CAUI-4 Ad hoc

Agenda

Figure 83D-2—Chip-chip insertion loss budget at 12.89 GHz

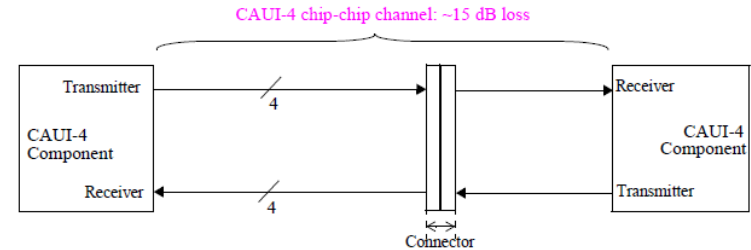
- TBC 15dB budget
 - Maintain TBC in next draft

Figure 83D-3—CAUI-4 chip-chip channel insertion loss

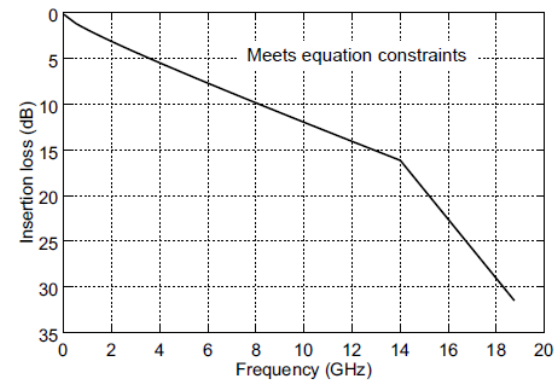
EDITORS NOTE: Insertion_loss equation is TBC

Figure 83A-8—Transmitter eye mask

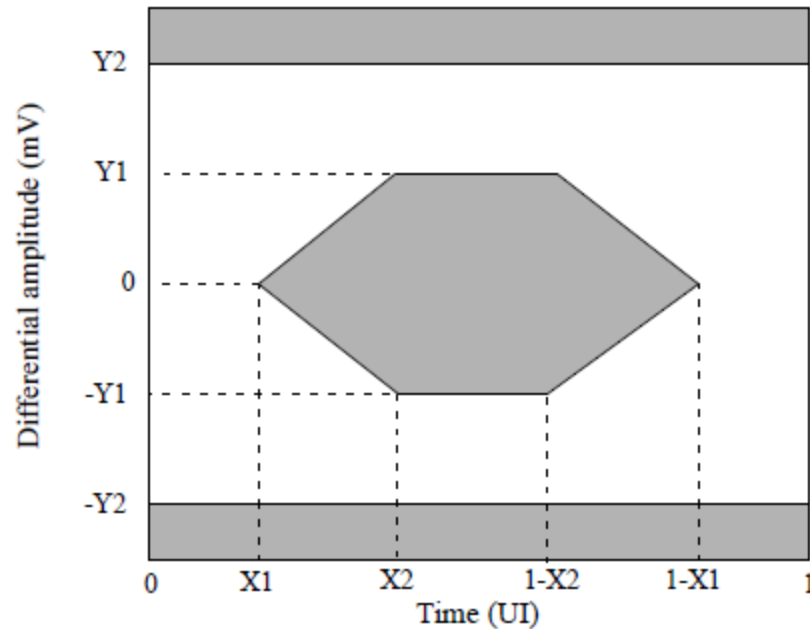
The above eye mask is defined at BER 1E-15, using the methodology described in section 83D.3.4. Transmitter de-emphasis may be adjusted for optimal mask results

Transmitter mask definition X1: 0.14
Transmitter mask definition X2: TBD
Transmitter mask definition Y1: TBD
Transmitter mask definition Y2: 600

Figure 93–7—Transmit equalizer functional model

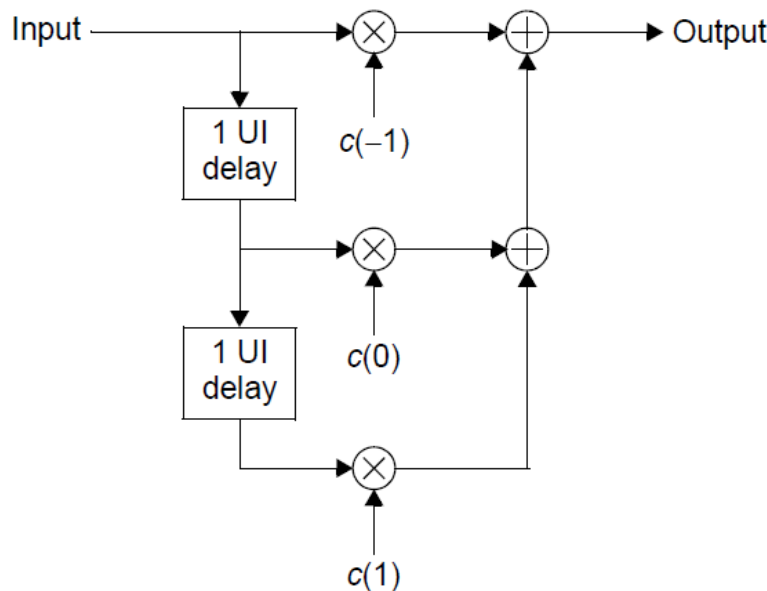
Add to section 83D.3.1.6

The CAUI-4 chip-chip transmitter includes programmable equalization to compensate for the frequency-dependent loss of the channel and facilitate data recovery at the receiver. The functional model for the transmit equalizer is the three tap transversal filter shown in TBD. The minimum precursor de-emphasis ($c(-1)$) is TBD. The minimum post cursor de-emphasis ($c(1)$) is TBD.
